Subject: Lodi Energy Center (08-AFC-10)
Supplement D -Changes to Equipment and Project Fenceline

Application for Certification

Supplement D
Changes to Equipment and Project Fenceline

California Energy Commission

FIGURE 5.13-3R
KEY OBSERVATION POINT 2
 LODI ENERGY CENTER
 LODI, CALIFORNIA

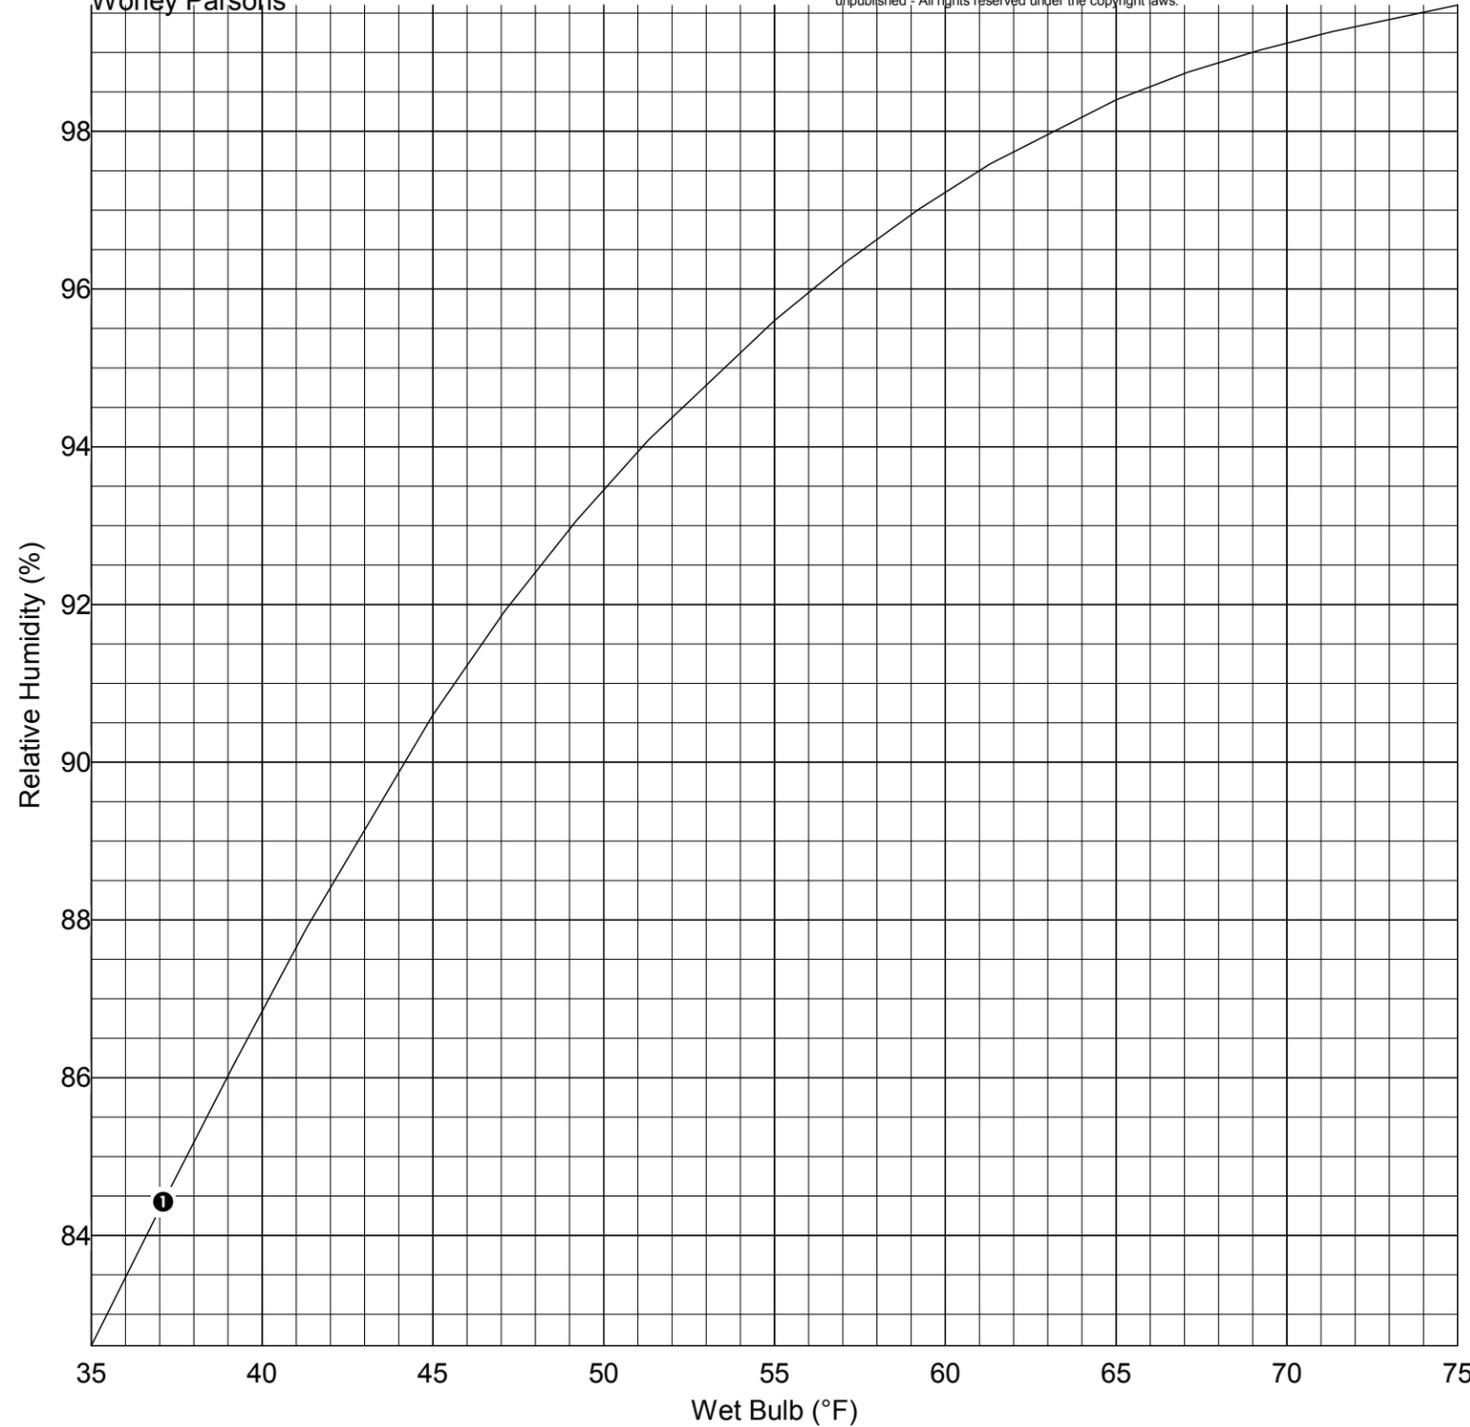
Modification	Reason for Change
Figure 5.13-3R, KOP-2	Equipment changes resulted in minor changes to the plant simulations. Equipment changes are only visible in KOP-1, KOP-2, and the Oblique Rendering of plant.
Figure 3.13-1, Fogging Frequency Curve	A Fogging Frequency Curve has been provided as a new figure.
AFC Sections	
Section 2.0, Project Description	The Siemens equipment is different in type from the originally proposed GE equipment, and requires minor changes to the Project Description chapter. A revised project description chapter is provided in underline/strike-out as Appendix A.
Section 5.1, Air Quality	As a result of the equipment change and small footprint modification, minor changes have been made to Section 5.1, Air Quality. A revised Air Quality chapter is provided in underline/strike-out as Appendix C.
Section 5.5, Hazardous Materials	As a result of the equipment change, minor changes were required for Section 5.5 Hazardous Materials. Hydrogen has been removed from the project, and sulfuric acid quantities have increased slightly. The changes were minor enough that a complete revision of the Hazardous Materials chapter was not required, and all revisions are provided in Section 3.5 of the Supplement.

FIGURE 5.1B-7R
Building Layout for GEP Analysis

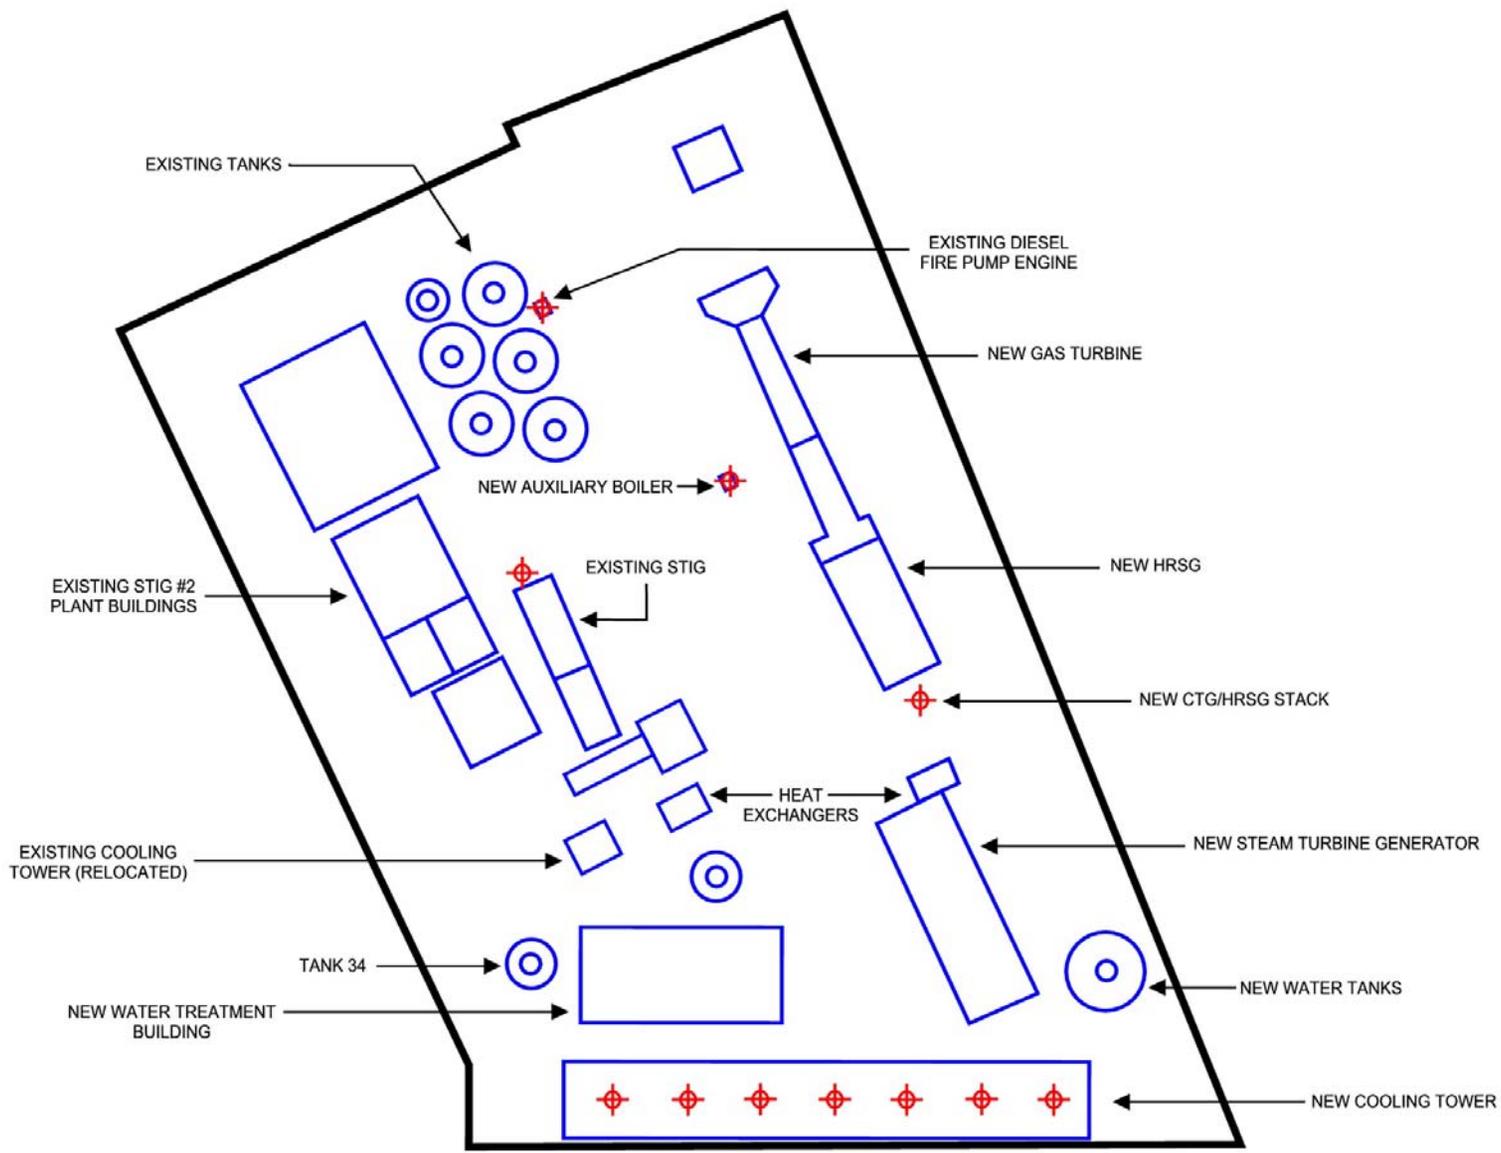
Figure 5.1B-1R in Appendix 5.1B shows the building layout used in the modeling analysis. The facility fenceline has also been changed slightly to avoid biologically sensitive habitat. Since the new equipment will operate alongside the existing plant, the modeling analysis included the existing STIG plant structures to account for any potential influences from those structures. The impact analysis was used to determine the worst-case ground-level impacts of the new equipment. The results were compared with established state and federal ambient air quality standards and PSD significance levels. If the standards are not exceeded then it is assumed that, in the operation of the facility, no exceedances are expected under any conditions. In accordance with the air quality impact analysis guidelines developed by EPA (40 CFR Part 51, Appendix W: Guideline on Air Quality Models) and CARB (Reference Document for California Statewide Modeling Guideline, April 1989), the ground-level impact analysis includes the following assessments:
